NEW MEXICO ENERGY, MINERALS and NATURAL RESOURCES DEPARTMENT

Mark E. Fesmire, P.E.
Director
Oil Conservation Division

LETTER OF VIOLATION - Inspection

SUMMIT RESOURCES inc.
PEARL JORDAN #3 AND T/B.
P 17-4S-33E 30-04-20593

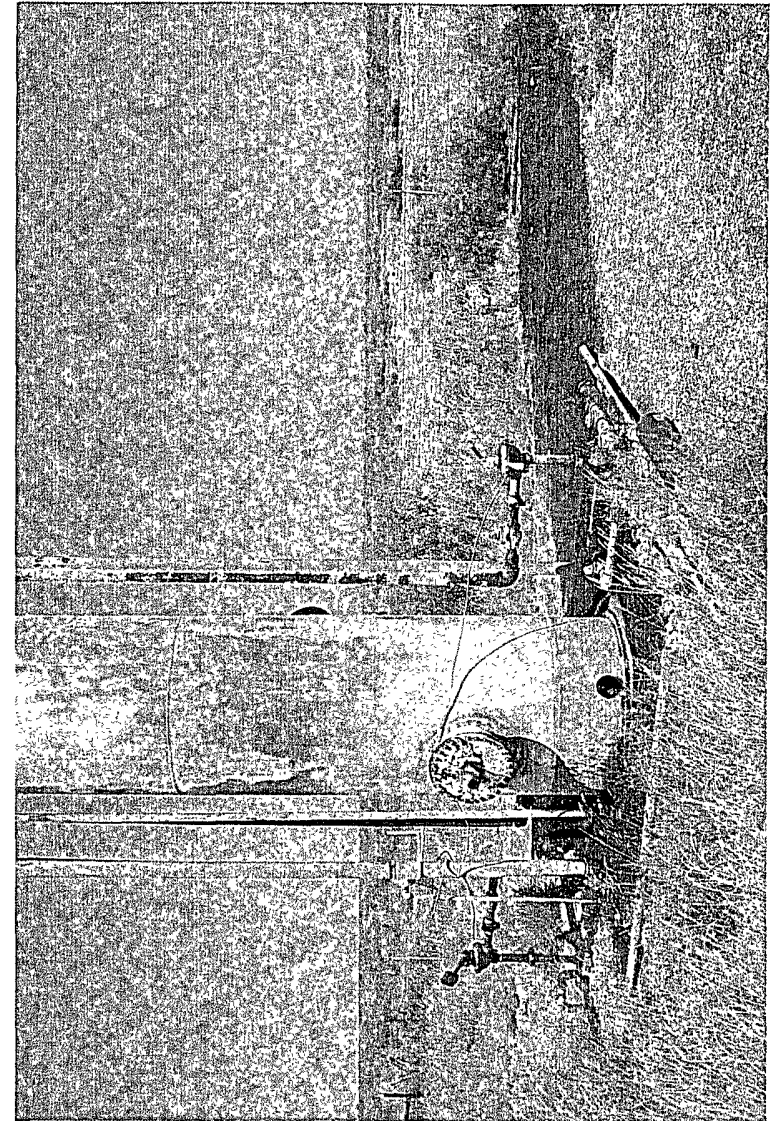
Comments on Inspection: FOLLOWUP ON COMPLAINT FROM WAYNE KINMAN-RANCHER IN REFERENCE TO FLOWLINE LEAK. NEED TO SUBMIT C-141 TO GEOFFREY LEKING (575-393-6161 EXT 113), HOBBS OCD DISTRICT 1 OFFICE FOR APPROVAL. RULE 19.15.29.8. ALSO NEED TO ADDRESS RELEASES AT TANK BATTERY. SEE PHOTOS-LOAD LINE, SUMP, AREA NORTHEAST OF HEATER TREATER AND AROUND WELLHEAD. SIGN AT WELL NEEDS CURRENT OPERATOR AND API#, RULE 19.15.16.8. NEED TO INSTALL SIGN AT TANK BATTERY, RULE 19.15.18.16. THIS IS 1ST LETTER OF NON-COMPLIANCE.

FLOWLINE LEAK 4' X 300' +/-

LOADLINE

SUMMIT
PEARL JORDAN
TANK BATTERY

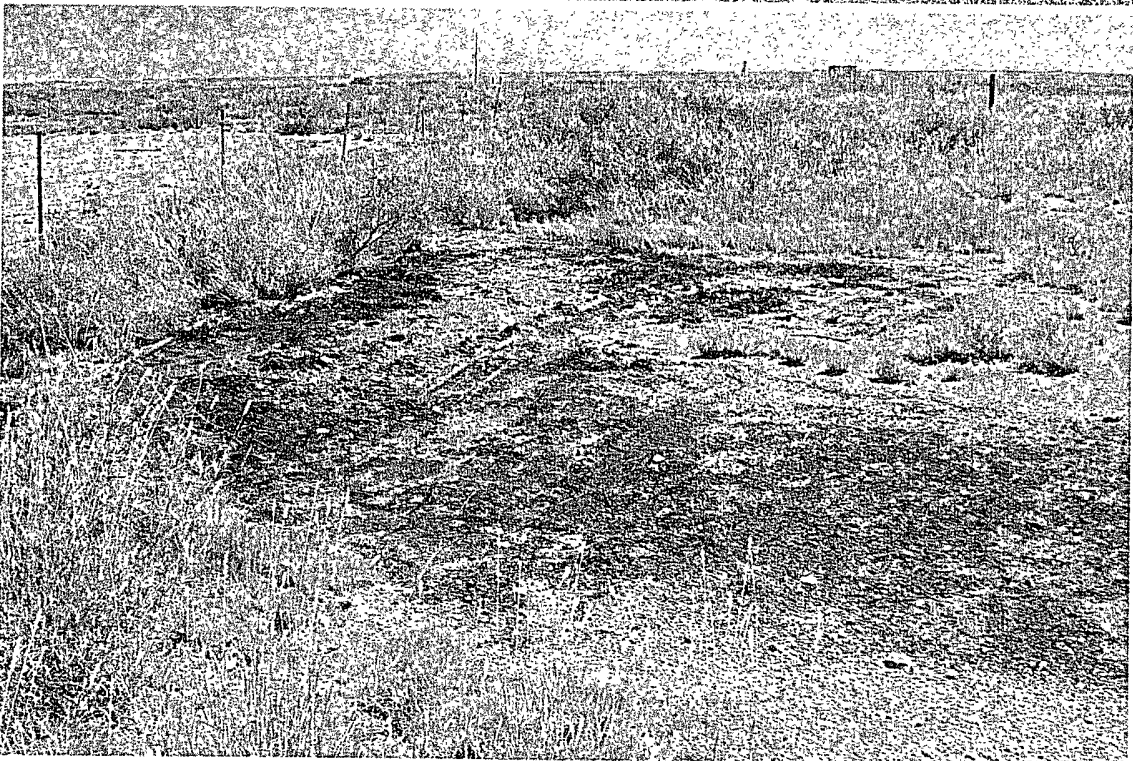
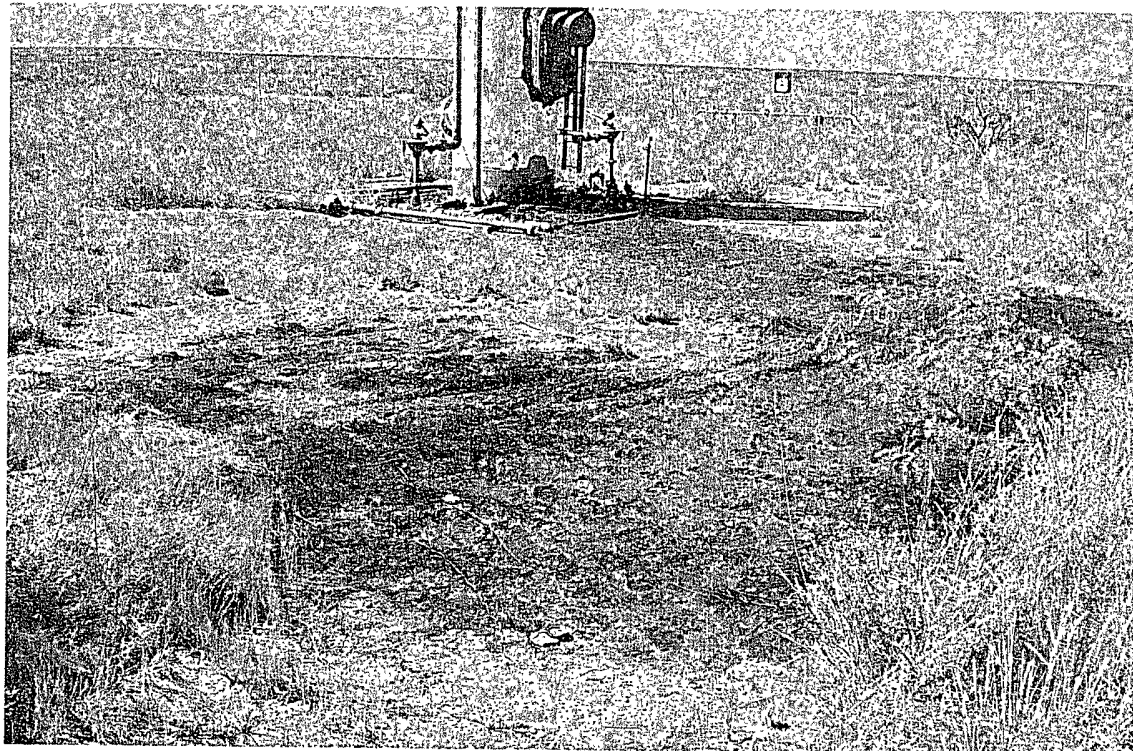
SUMP
←

TREATED
LEAK
↓

LOADLINE
←

AREA AROUND WELLHEAD
←

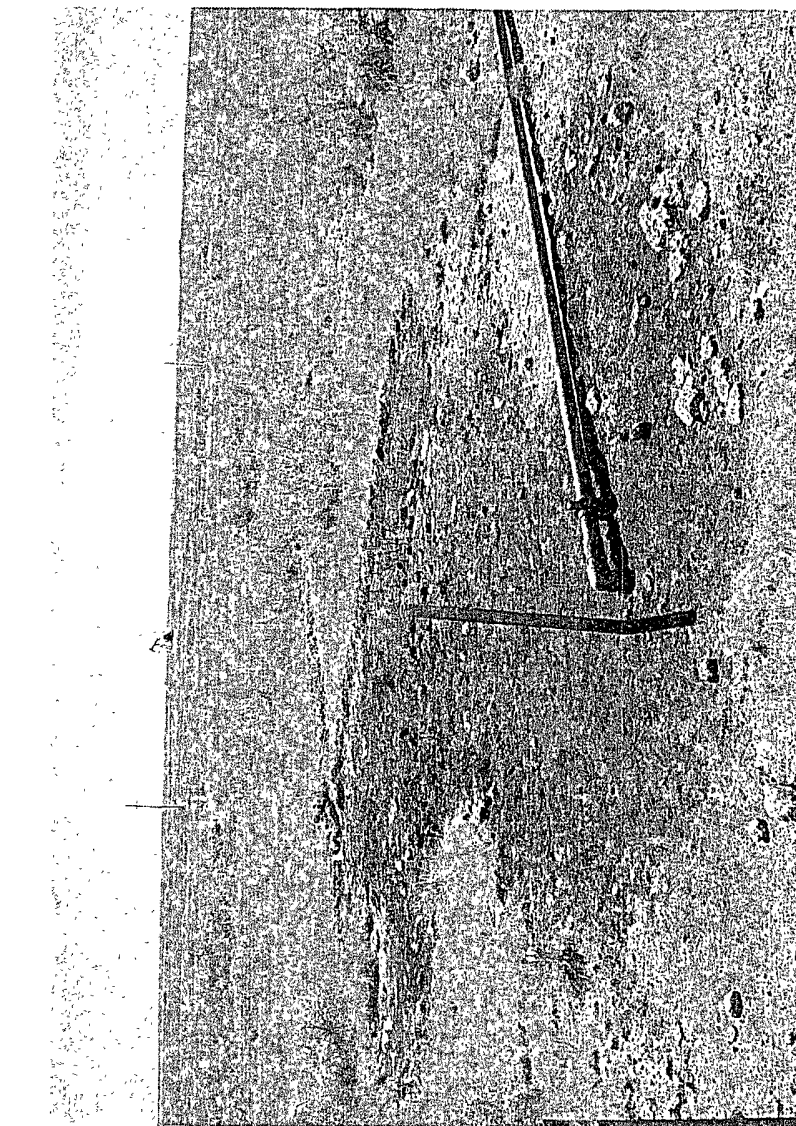
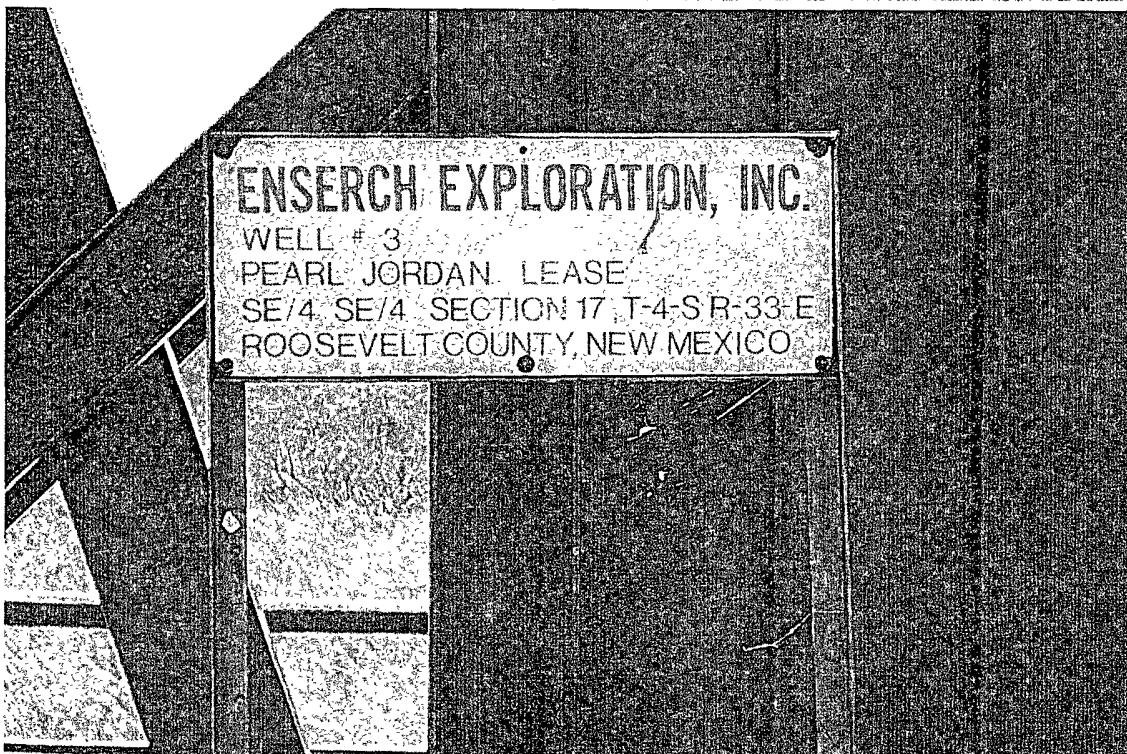
AMOCO STATE No.002				M-16-4S-33E	30-041-20544-00-00	
Inspection Date	Type Inspection	Inspector	Violation?	*Significant Non-Compliance?	Corrective Action Due By:	Inspection No.
09/01/2010	Routine/Periodic	Maxey Brown	Yes	No	12/5/2010	iMGB1024457444
Violations						
Absent Well Identification Signs (Rule 103)						
Surface Leaks/Spills						
Comments on Inspection: Well Sign (Rule19.15.16.8). NEED CURRENT OPERATOR ON SIGN. ALSO ADDRESS OIL STAINING AROUND WELLHEAD. THIS IS 1ST LETTER OF NON-COMPLIANCE.
